Reliability Analysis Update

Transmission Expansion Advisory Committee

April 6, 2021

Changes to Existing Projects

115kV Line #81 and 230kV Lines #239 and #2056 Partial Rebuild

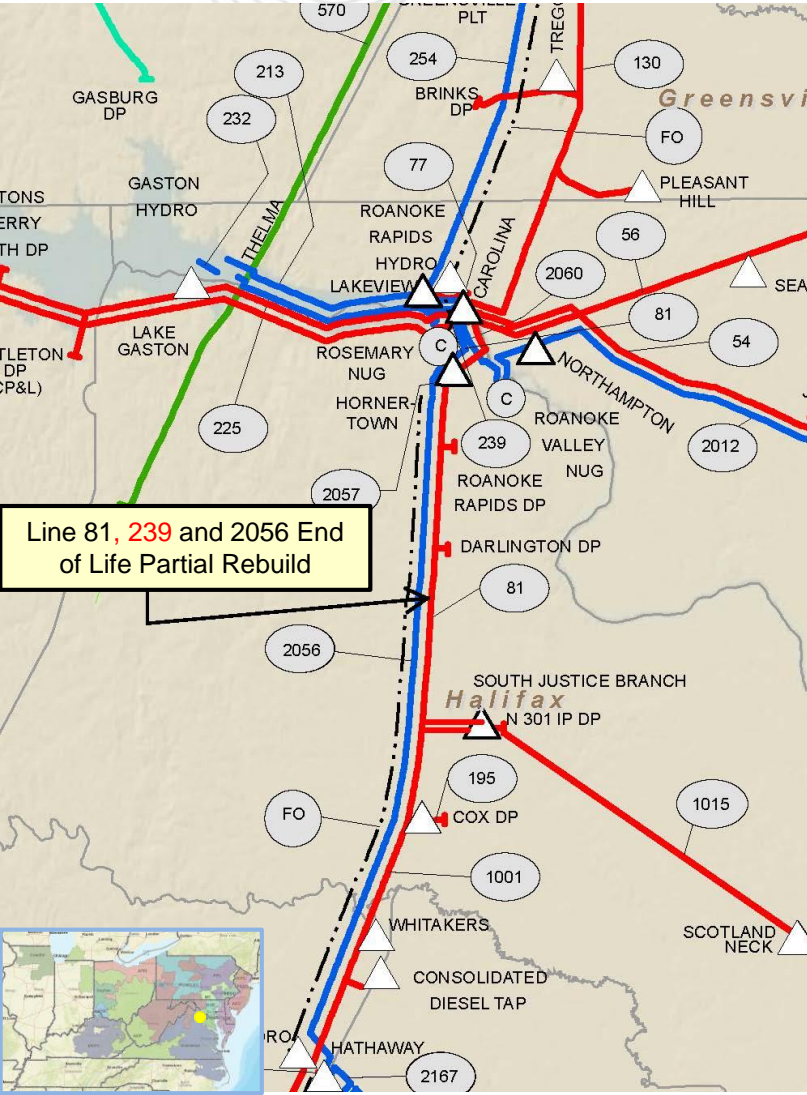
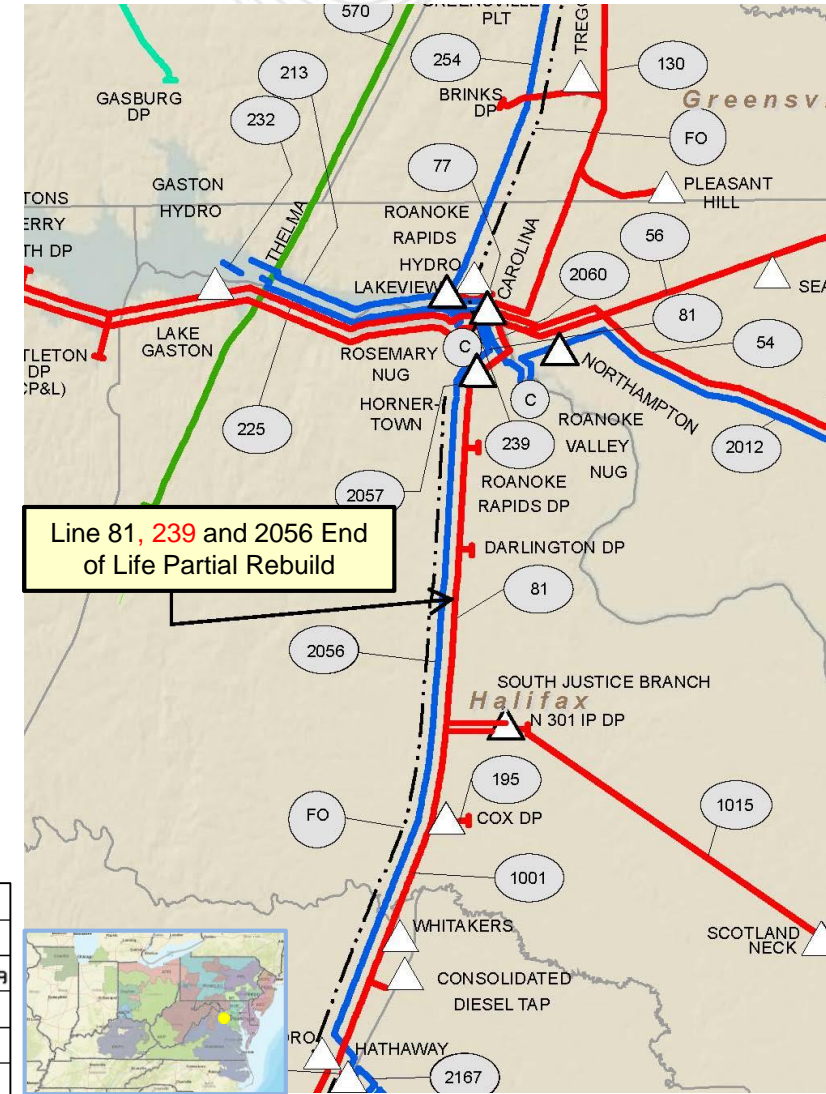
Problem Statement: Dominion “End of Life Criteria”

- 115kV Line #81 extends 21.6 miles from Carolina to South Justice Branch and serves 3 delivery points: Roanoke Rapids DP, Darlington DP, and Hornertown. The 18.6 mile section between Carolina and the tap to South Justice Branch is mostly wood H-frames constructed in 1959.

- There are two sections, 1.7 miles total, within the 18.6 mile section that have double circuit structures that are V series Corten. 115kV Line #81 and 230kV Line #2056 are on these double circuit structures. **Additionally, 115kV Line #81 and 230kV Line #239 are on double circuit steel structures for 1.3 miles within the 18.6 mile section. These structures were installed in 1967.** The conductor on this line is ACSR and the static wire is 3/8 inch steel.

- Industry guidelines indicate equipment life for wood structures is 35-55 years, conductor and connectors are 40-60 years, and porcelain insulators are 50 years.

Rebuild the 18.6 mile section of 115kV Line #81 which includes 1.7 miles of double circuit Line #81 with 230kV Line #2056 and 1.3 miles of double circuit Line #81 with 230kV Line #239. This segment of Line #81 will be rebuilt to current standards with a minimum rating of 261 MVA. This segment of Line #239 will be rebuilt to current standards with a minimum rating of 1046 MVA. Line #2056 rating will not change. (b3114)

Chickahominy 230kV Breaker “SC122”, “205022”, 209122”, 210222-2”, “28722”, “H222”, “21922”, “287T2129” Replacements

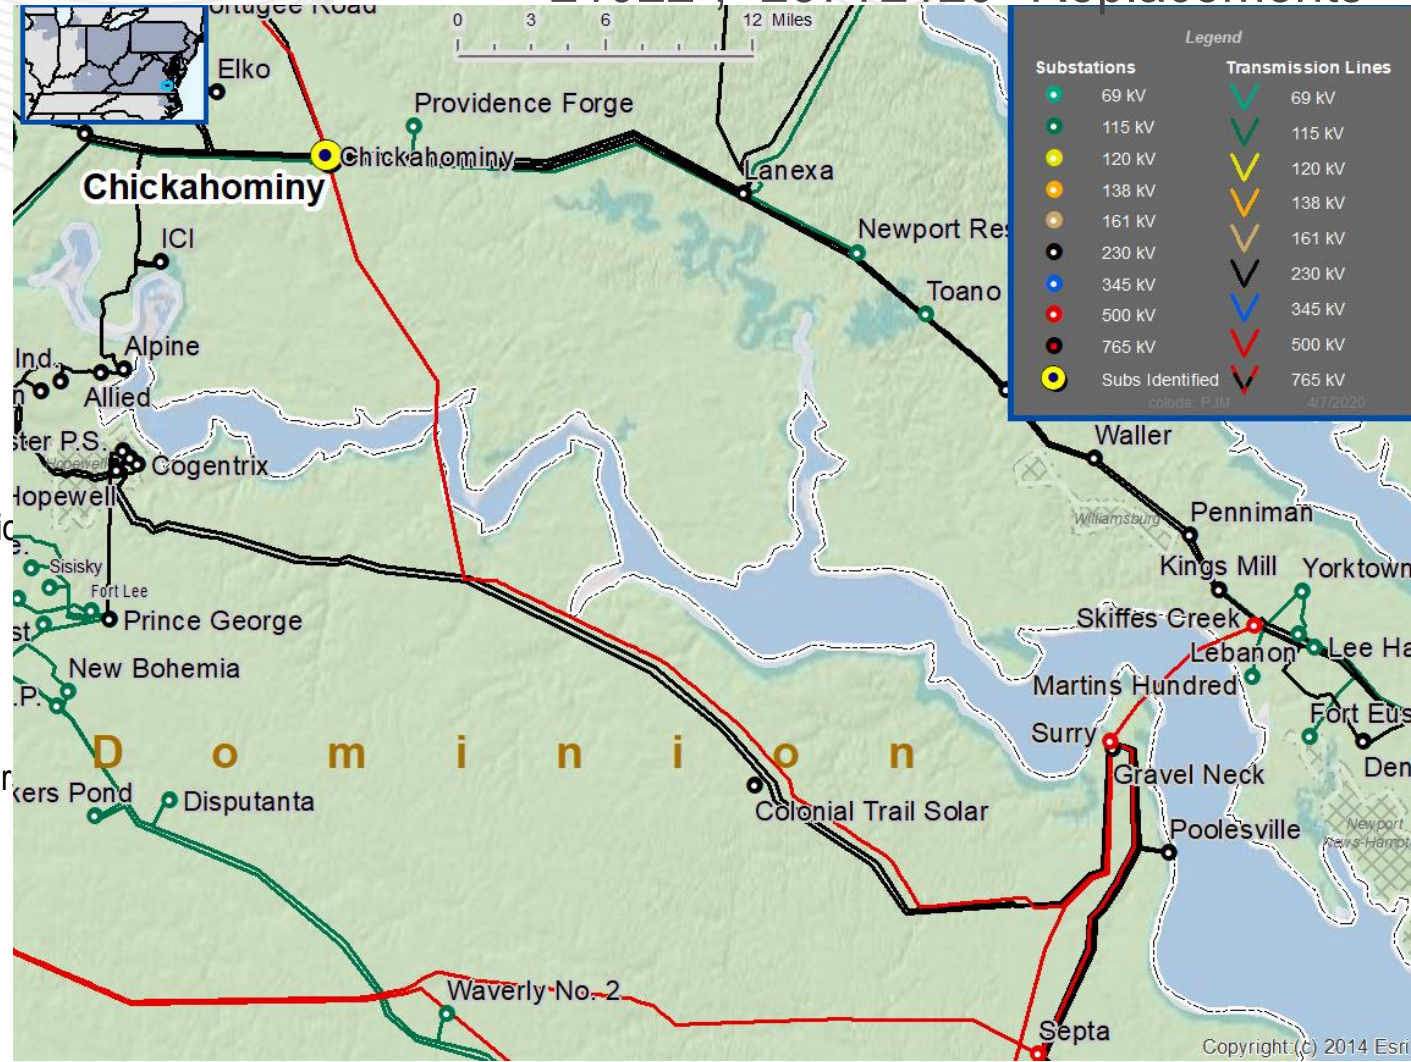
Eight (8) Chickahominy 230kV breakers are over duty: “SC122”, “205022”, 209122”, 210222-2”, “28722”, “H222”, “21922”, “287T2129”

Solution Cancellation Driver: AB2-068 Generator Withdrawn

b3213.1: Replace the eight (8) Chickahominy 230kV breakers with 63kA breaker “SC122”, “205022”, 209122”, 210222-2”, “28722”, “H222”, “21922”, “287T2129”

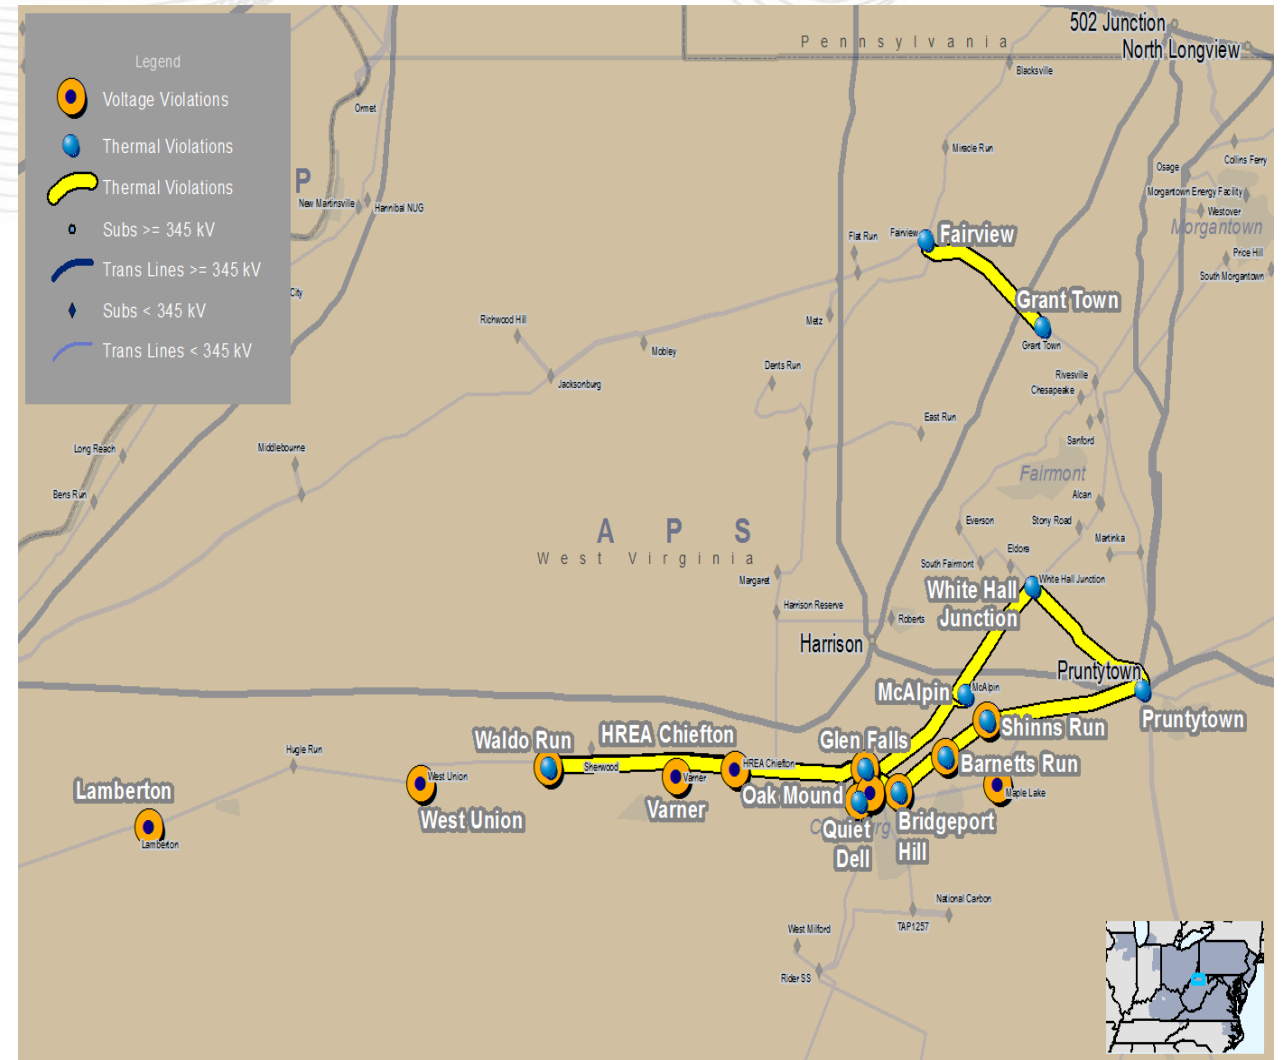
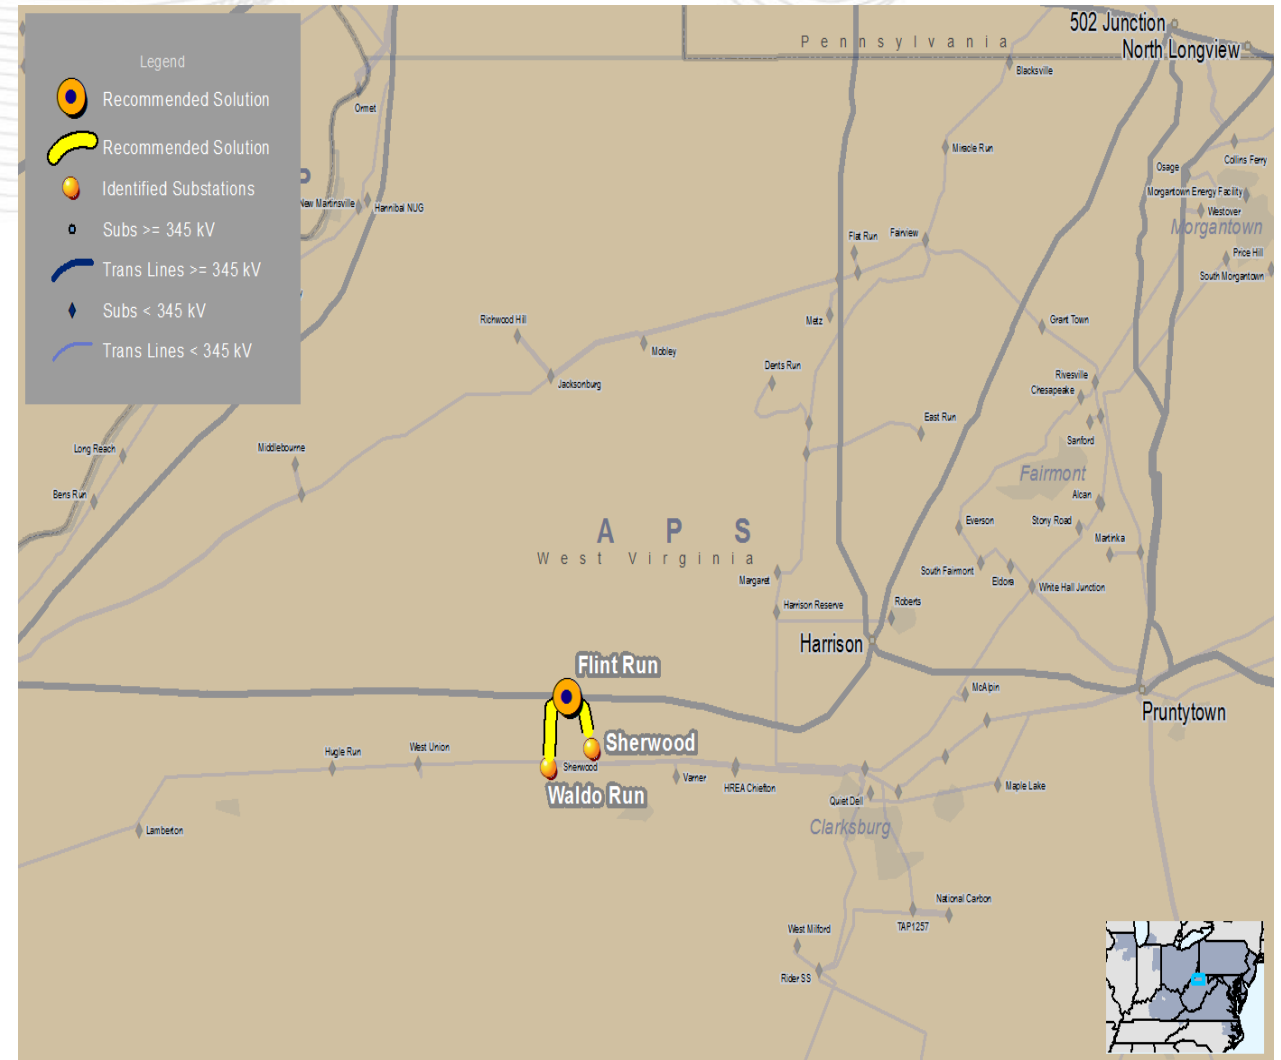
Increased customer load expectations connected to the Waldo Run 138 kV substation are causing several Gen Deliv, N-1 Thermal, and N-1 low voltage violations in the vicinity of Waldo Run, Oak Mound, Pruntytown and Fairview.

Increased cost of ~\$102M primarily due to:

- 138 kV line work increased **\$43M**
 - Design changed to steel poles
 - Line length increased 0.7 mile
 - Access roads
 - Vegetation control
- Substation location change increased **\$41M**
 - Additional civil and environmental engineering/construction
 - Real estate costs
- Other cost increases **~\$10M**
 - Retaining wall at Waldo Run Substation
 - Additional Engineering, Project Management, etc.

Construct a new 500/138 kV substation as a four-breaker ring bus with expansion plans for double-breaker-double-bus on the 500 kV bus and breaker-and-a-half on the 138 kV bus to provide EHV source to the Marcellus shale load growth area. Projected load growth of additional 160 MVA to current plan of 280 MVA, for a total load of 440 MVA served from Waldo Run substation. Construct additional three-breaker string at Waldo Run 138 kV bus. Relocate the Sherwood #2 138 kV line terminal to the new string. Construct two single circuit Flint Run - Waldo Run 138 kV lines using 795 ACSR (approximately **3.7 miles**). After terminal relocation on new 3-breaker string at Waldo Run, terminate new Flint Run 138 kV lines onto the two open terminals.(b2996.1) **\$125.3M**

Loop the Belmont-Harrison 500 kV line into and out of the new Flint Run 500 kV substation (less than 1 mile). Replace primary relaying and carrier sets on Belmont and Harrison 500 kV Remote End Substations.(b2996.2) **\$16.6M**

Upgrade two (2) existing 138 kV breakers (Rider 50 and #1/4 transformer breaker) at Glen Falls with 63 kA, 3000 A units. (B2996.3) **\$1.5M**

Terrain of 138 kV double circuit

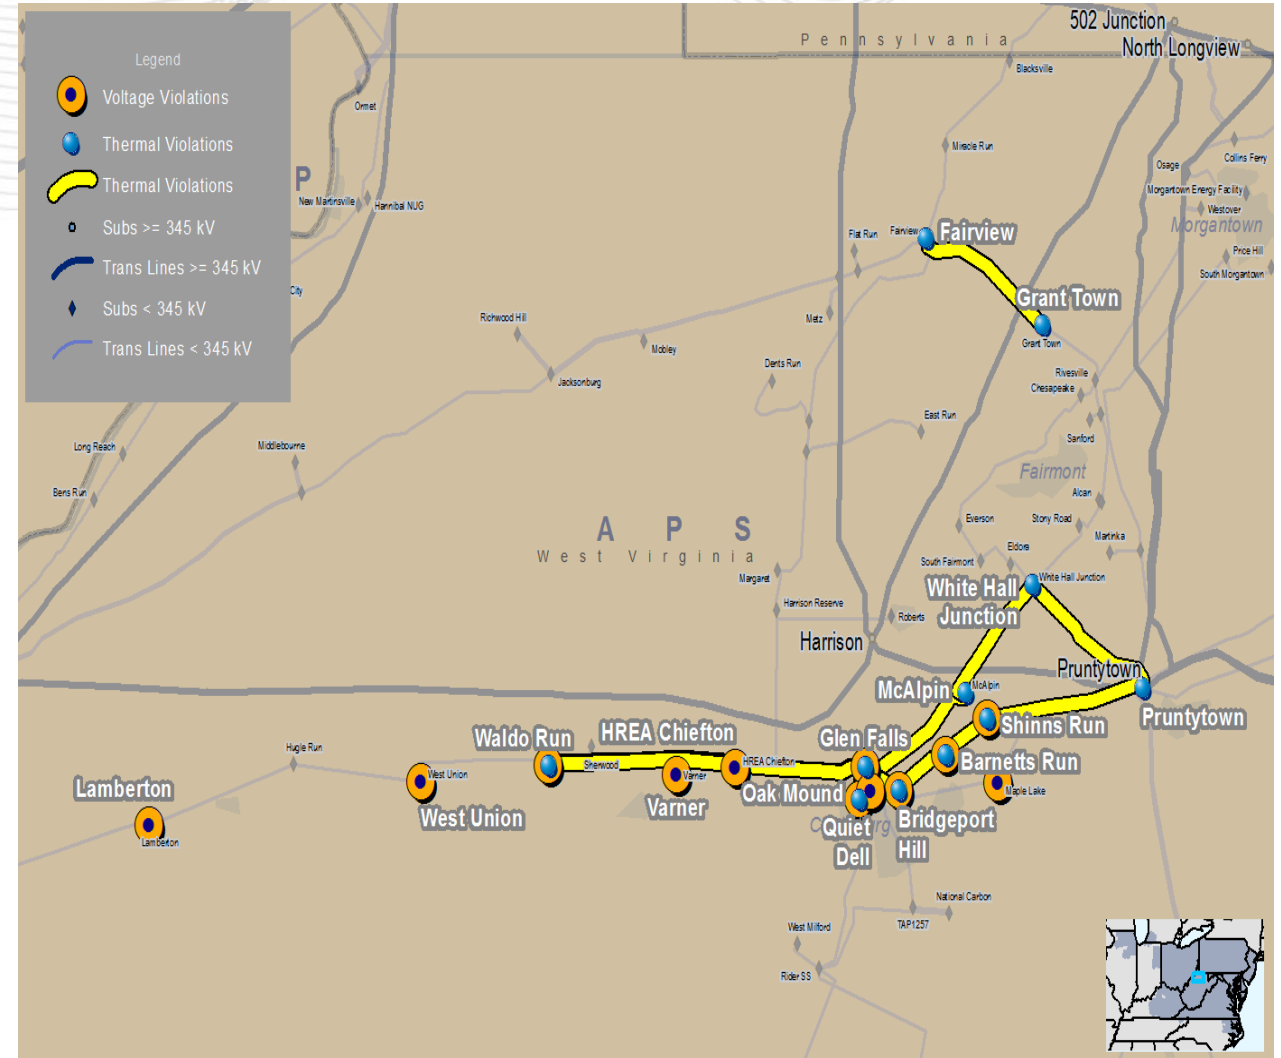
Increased cost of alternatives primarily due to:

1. Reconducting alternative was a desktop estimate. No detail from original estimate.
 - More refined estimate prepared for this update
 - Increased cost of \$104M based on present estimating information for reconducting
2. New Pruntytown-Oak Mound line increased \$156M
 - Additional reconducting project identified on double circuit 138 kV line (\$78M)
 - Access road costs (\$48M)
 - Change in line design (\$16M)
